10/21/96 VACATION OF DRAINAGE/UTILITY  
EASEMENT-JYLNAD DENNIS ADDITION

AGENDA ITEM: IV.A.

Re: Drainage Easement #14 Bello  
More Filling Within This Easement

## REPORT/RECOMMENDATION

SURVEY FOR: SID REBERS

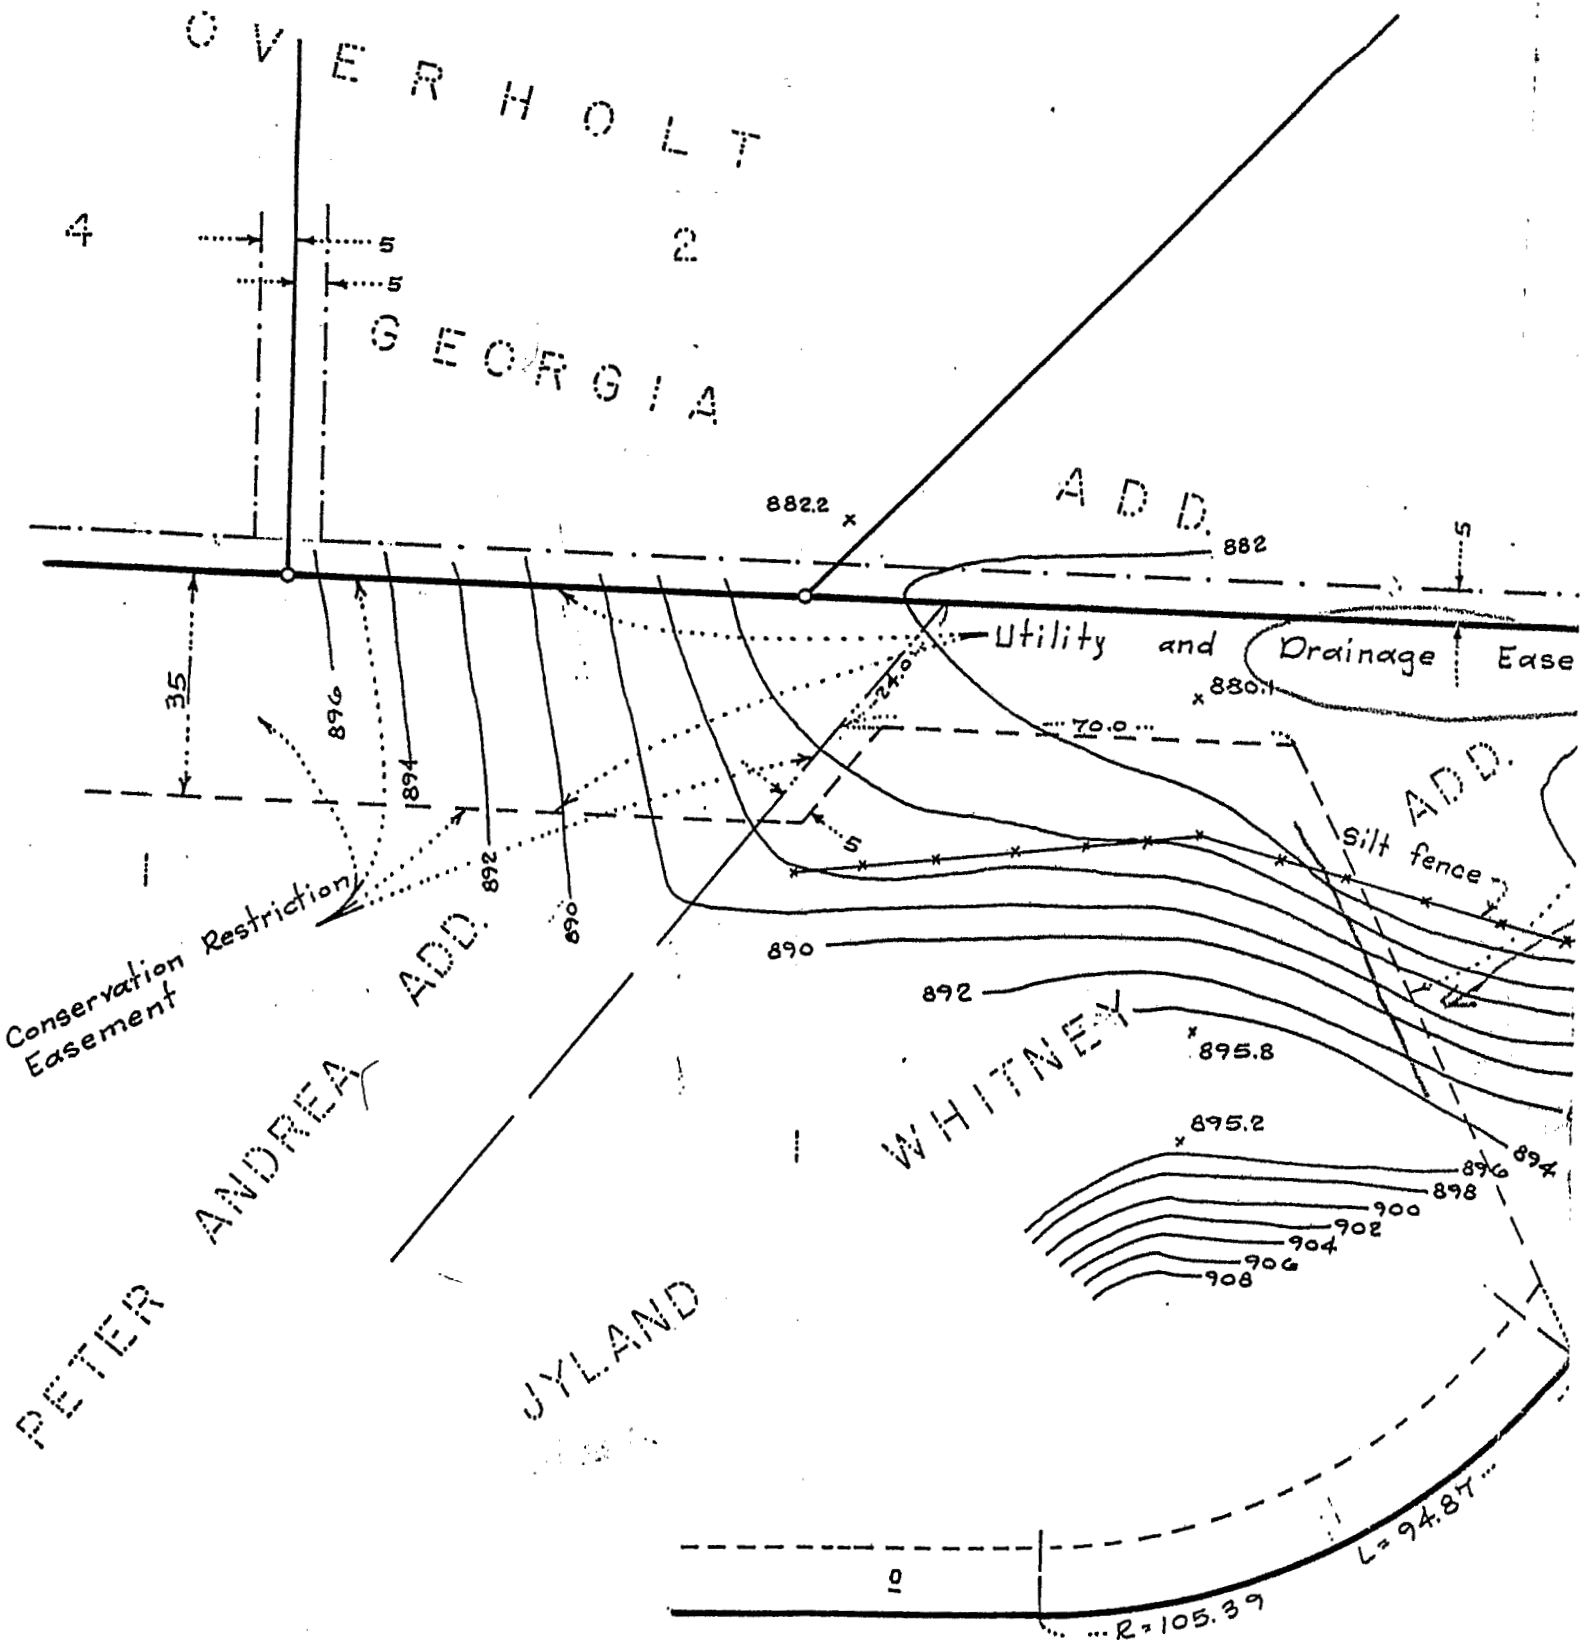
Refer to attached survey of Schoell & Madson dated February 20, 1993. This shows a violation of approximately 40 feet at the time the owners (Mr. and Mrs. Dennis) had their home built.

PROPOSED RETAINING WALL AND EASEMENT

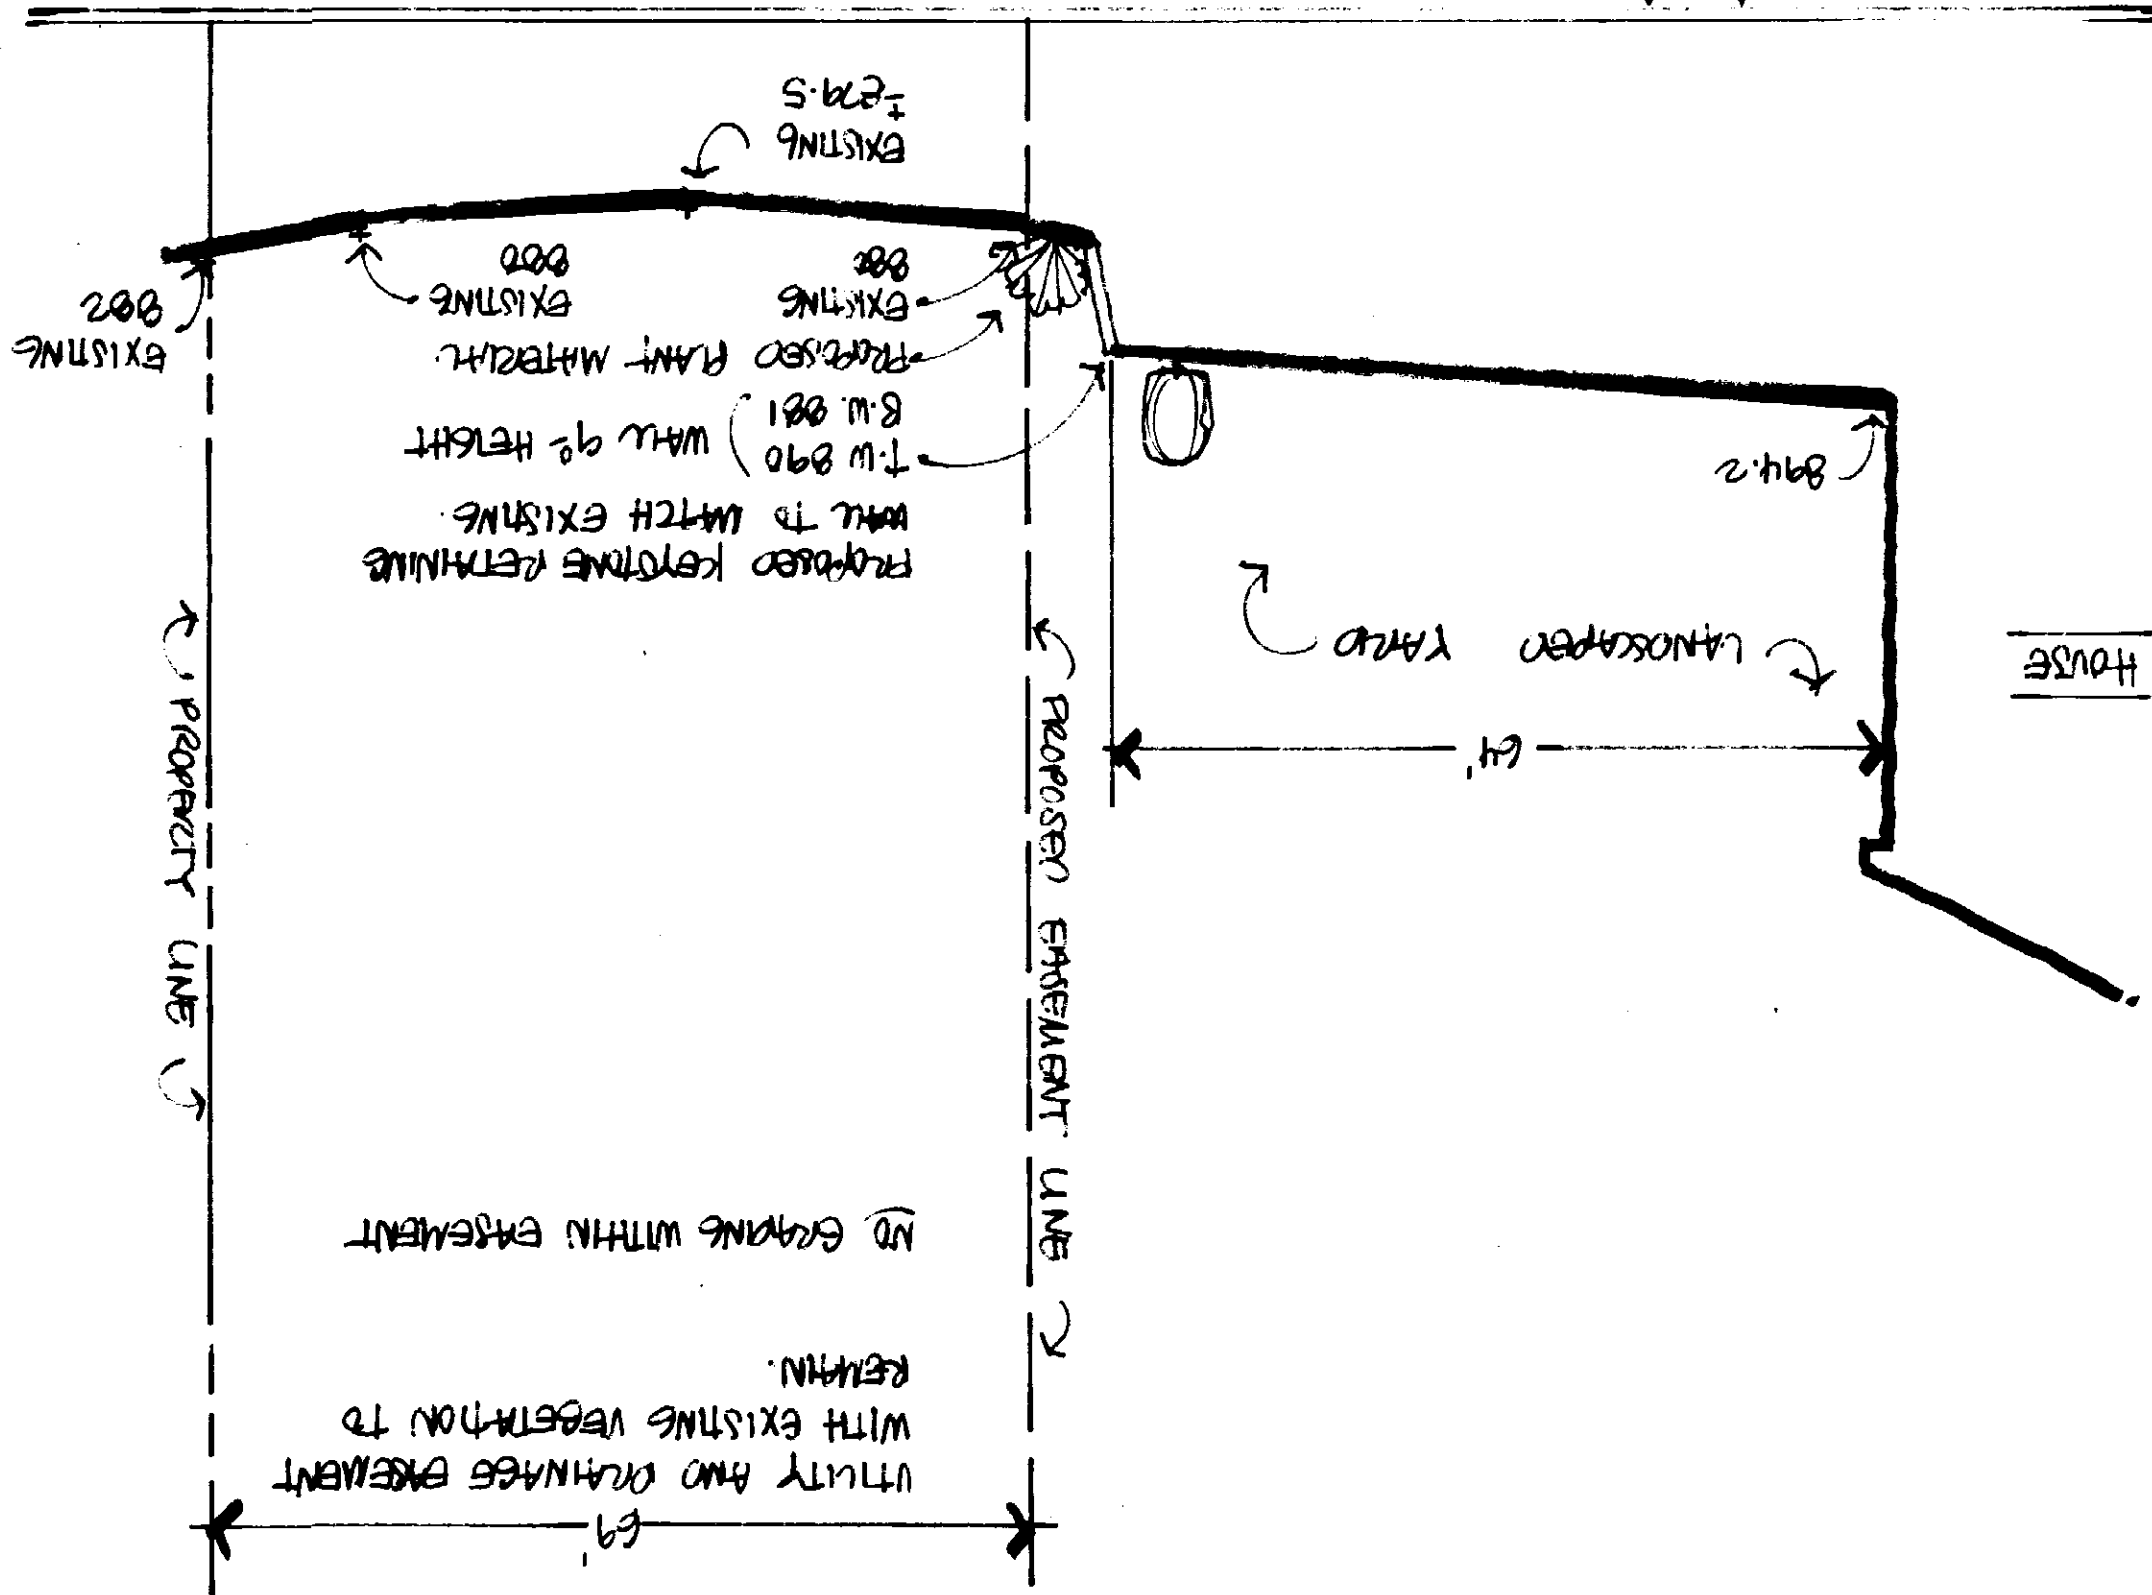
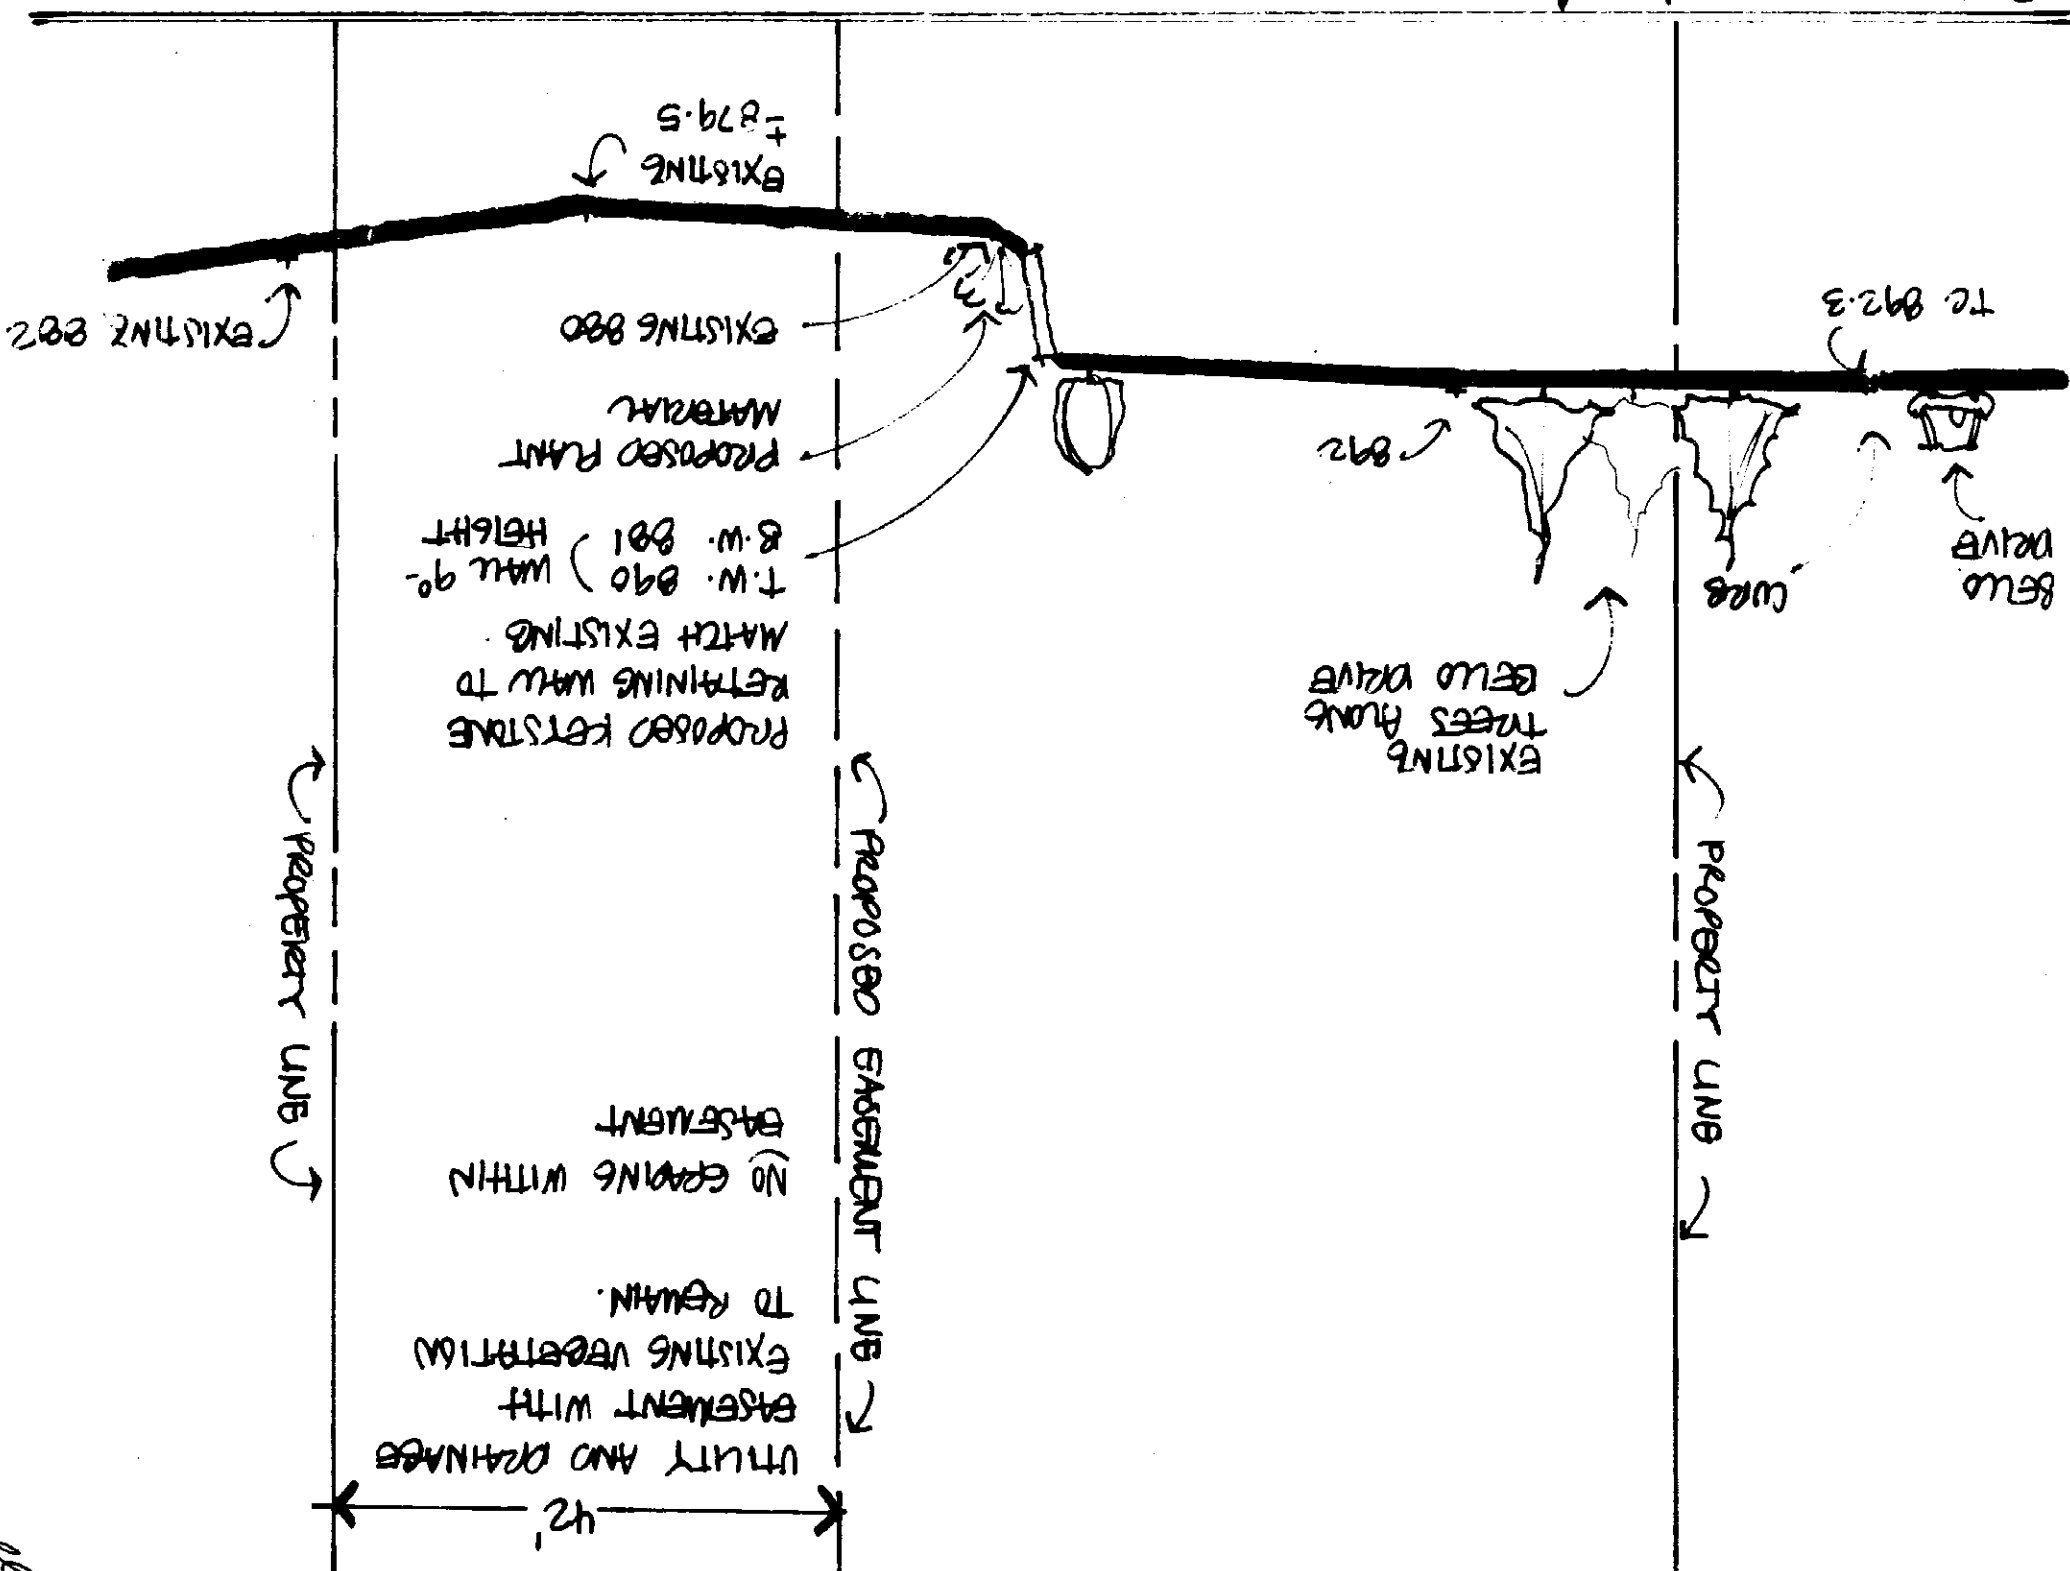
At this time, Judy and I were given copies of McCombs Frank Roos Associates' Report dated July 24, 1996. This report showed without accurate dimensioning or height of wall further gross filling within

the drainage easement and also showed previous violation (without permit) of this drainage easement.

At the meeting with Mrs. Dennis, Judy Knudsvig, Kevin and Fran Hoffman this week, I asked Kevin to relocate the new retaining wall back from the elevation 880 and closer to the existing North-South drainage easement line and to show elevation of this wall. As of 4:00 p.m. on October 31, 1996, I have not heard from him.
